DESIGN REVIEW BOARD

DRB2013-01

Design Review of a new commercial restaurant

PANDA EXPRESS RESTAURANT 1500 MARKET PLACE DRIVE

EXHIBIT D - PANDA EXPRESS LANDSCAPE PLAN

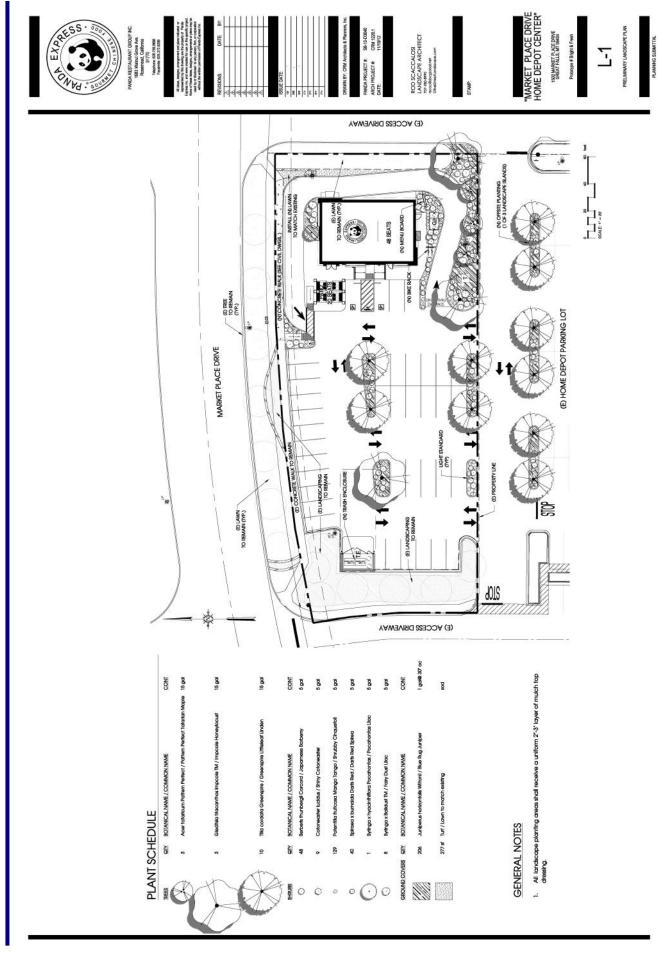
The applicant is proposing to leave the existing landscaping in the boulevard of Market Place Drive and on the east property line adjacent to the access drive. LDC 17.44.3.030 C requires that vehicular use areas be mounded a minimum of 6 inches above the height of the vehicular use area. The plans that were submitted as a part of this application do not have spot elevations noted on the plans for the existing grade, but it would appear this provision is being met. The existing sidewalk will remain adjacent to Market Place Drive. New landscaping is proposed in the parking lot and around the new building. Title 17.44.3.030(F), Foundation planting requirements, requires that 20% of each façade has foundation planting. Planter boxes are shown on the rendered plan, but there is no planting in this area noted on the landscape plan. Staff recommends the applicant install additional landscaping in the existing streetscape, east of the proposed building. The planting in this area will help to buffer the building and drive-through lane from the access driveway and will meet the intent of the code requirement to install foundation planting. Staff encourages the applicant to apply for a Design Waiver for the foundation planting area. The remainder of the proposed landscaping meets the requirements of the Land Development Code.

- ◆ The applicant shall meet the provisions of Title 17.44.3.030 I (Foundation Planting Requirements) or file for a Design Waiver where the intent of the Code can be met by installing landscaping in alternate areas.

EXHIBIT H - NORTH AND SOUTH ELEVATIONS

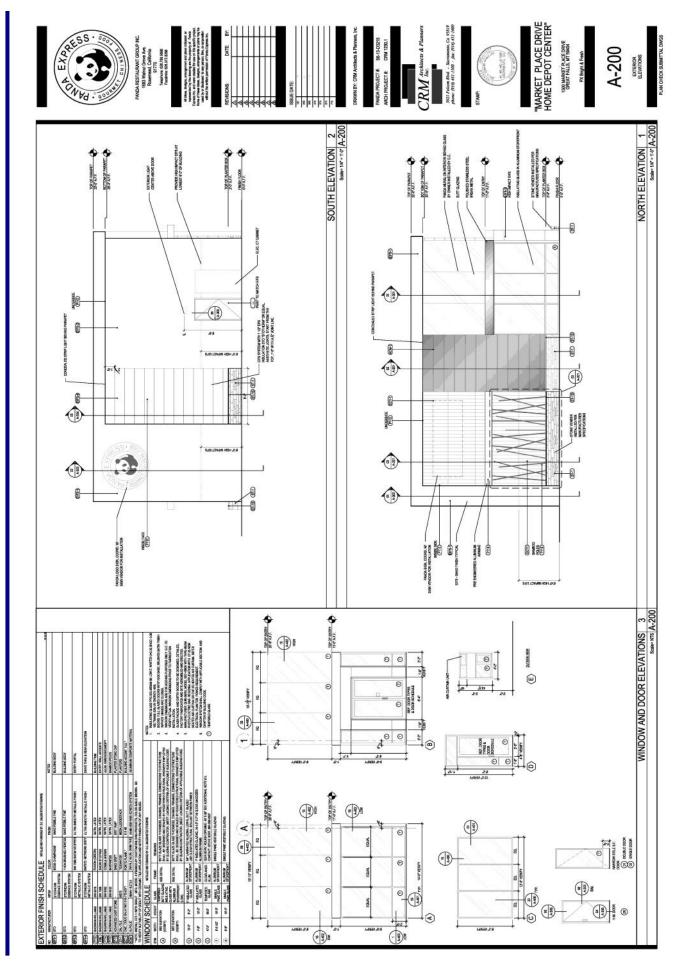
The primary façade is the western façade, oriented toward the parking lot. The Land Development Code (LDC) recommends that the primary entrance be focused toward the public street. In this case, a secondary façade faces Market Place Drive, where design elements and façade treatments create a visually appealing street facade. The drive-through wraps around the building along the southern, eastern and northern facades. The drive-through window is located on the east façade. The LDC recommends that a drive-through should not be located on the northern portion of a site. Staff encourages the applicant to work with the City Engineer to ensure that there is positive drainage in the drive-through area to discourage the formation of ice. The northwest corner of the building is accented by a floor to ceiling glass wall with a mural of a panda installed on the interior face of the glass. The north and west facades also incorporate a bamboo accent element made of painted aluminum pipes. A rendering of a typical restaurant has been included in this report. The architectural features of the building are consistent and are carried throughout all sides of the building. The design includes EPIS as the primary building material with glass, building accent tile, aluminum composite and stone veneer used to contrast and accent portions of the building.
